Subject: Agenda for 66th Protection Sub-Committee Meeting.

Agenda of 66th Protection Sub-Committee Meeting (28th January, 2026)

Agenda: Revised 220 kV lines and transformers for Installation of Special Protection Scheme (SPS) on 400/220 kV transformers at PGCIL 400/220 kV Substations in Rajasthan Control area

Stage-1 SPS Operation : Tripping of 160 MVA, 220/132 kv transformers at 220 kV GSS Bamantukda
EXHIBIT-1A

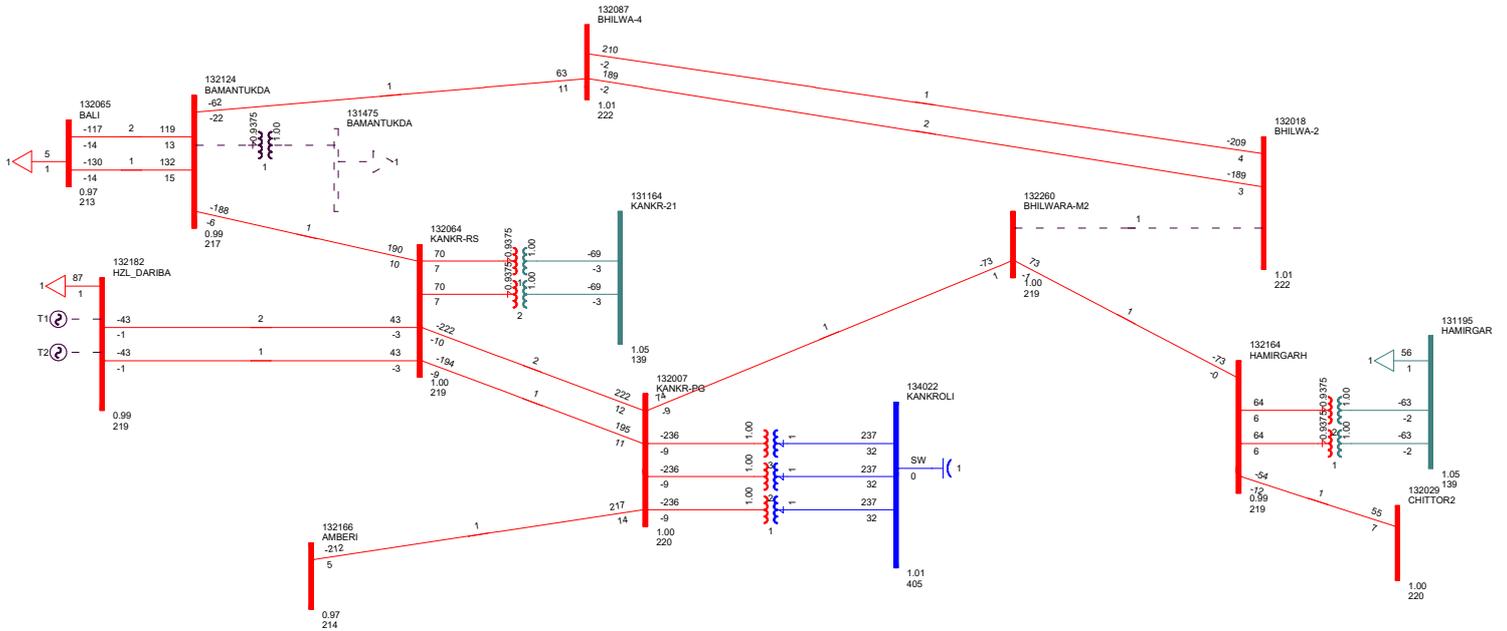
Stage-2 SPS Operation : Tripping of 220 kV S/C Kankroli(PG)-Bhilwara line
